Access Compliance Report

Public Rights-of-Way

Intersection ID: 28187	Main Street: LINDRICK_LN	Cross Street: SAUNTON_CT	Location: SE
ADA ID: 261836CB8B28	Ramp Type: BlendTrans2	Initial Pass/Fail: Pass	Overall Compliance: No
Severity Score: 17.5			
Codes/Mitigation Info/Possible Solution		Field Measurements/Component Compliance

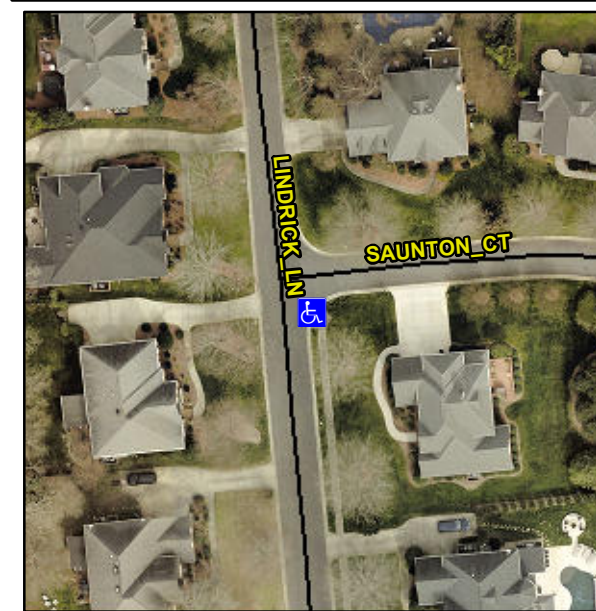
Not Found, R305, R302.7.2

Compliance	Description	Data	Compliance	Description	Data
N/A	Ramp Length (in)	97.0	Yes	BlendTrans Slope (%)	2.2
Yes	Ramp Width (in)	89.0	Yes	BlendTrans XSlope (%)	0.2
N/A	Flare Type LT	None	N/A	Flare Type RT	None
N/A	Flare Slope LT (%)	N/A	N/A	Flare Slope RT (%)	N/A
N/A	Flare Traversable LT?	N/A	N/A	Flare Traversable RT?	N/A
N/A	Landing Length (in)	N/A	No	DWS Provided?	No
N/A	Landing Width (in)	N/A	N/A	DWS Contrast?	No
N/A	Landing Slope (%)	N/A	N/A	DWS Length (in)	N/A
N/A	Landing X Slope (%)	N/A	N/A	DWS Full Width?	No
N/A	Landing Curb? (Y/N)	No	N/A	DWS Offset (in)	N/A
N/A	Shared Landing?	No			
Yes	Gutter Ponding?	No	Yes	Gutter Slope (%)	0.6
No	Gutter Lip Ht (in)	0.3	Yes	Gutter X Slope (%)	0.7
N/A	Painted X Walk1?	No	N/A	Painted X Walk2?	No
	X Walk 1 Direction	To N		X Walk 2 Direction	To W
	X Walk 1 Width (in)	N/A		X Walk 2 Width (in)	N/A
	X Walk 1 Slope (%)	1.6		X Walk 2 Slope (%)	1.6
	X Walk 1 X Slope (%)	3.3		X Walk 2 X Slope (%)	2.2

N/A	Ramp inside XWalk1?	N/A	N/A	Ramp inside XWalk2?	N/A
	Road Slope (%)	0.7		Clear Space?	Yes
	Road X Slope (%)	6.2	N/A	Clear Space to XWalk (in)	N/A
Yes	Any Obstructions?	No	Yes	Storm Grate/Utility Hazard?	No
	Obstruction Type			Storm Grate/Utility Type	
		N/A			N/A
			Yes	Surface Condition? (G/P)	Good
			No	Curb Slope (%)	14.3

Remove & Replace Curb Ramp With Two New Directional Ramps or Equivalent.
